INEEL Review

SFP RISK AT DECOMMISSIONED PLANTS

INTERNAL FIRE INITIATING EVENT

SFP RISK AT DECOMMISSIONED PLANTS
LOSS OF OFFSITE POWER
FROM SEVERE WEATHER EVENTS
CASE 1

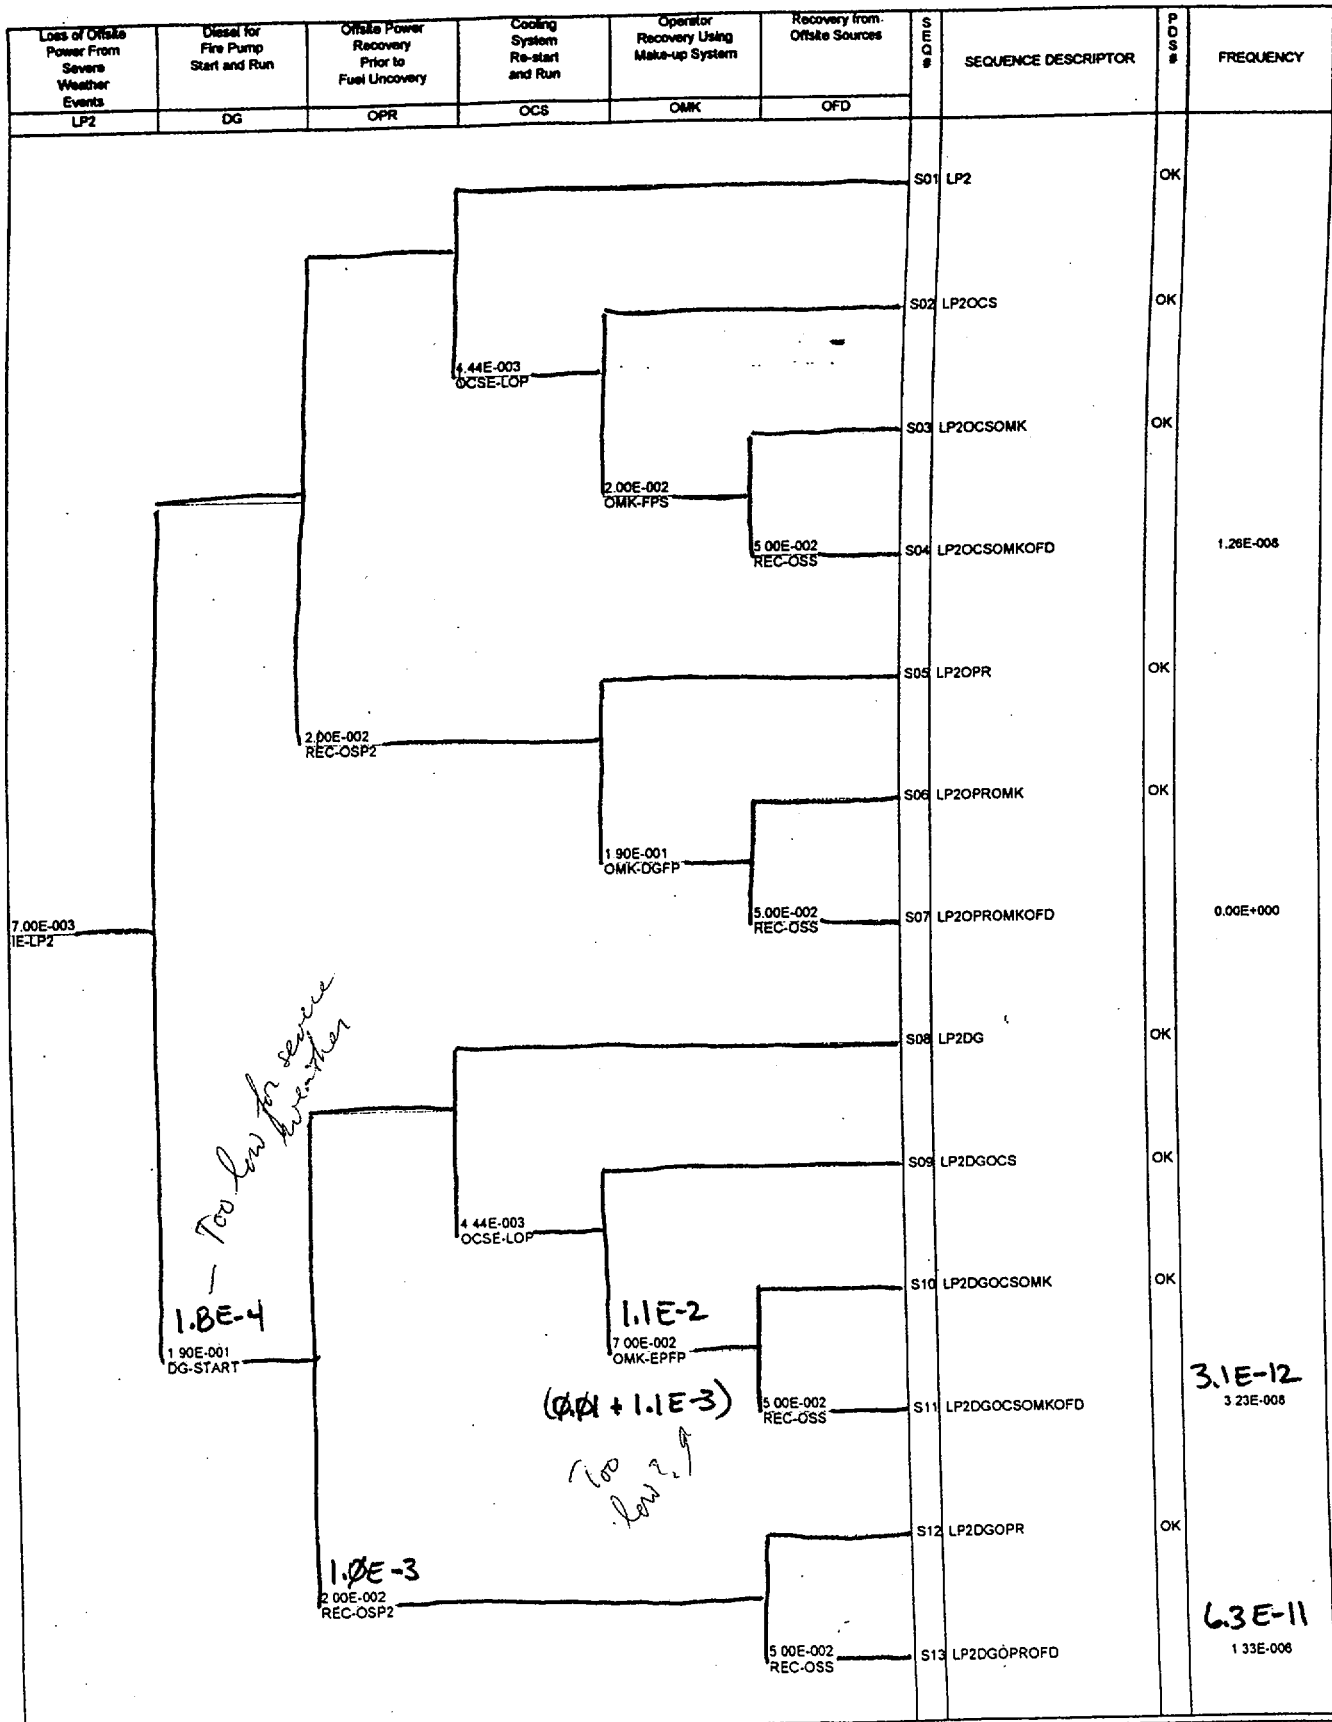
only unavailability of electric pumps

*See Appendix A-1
What is source of FP - EL PUMP - FTP*
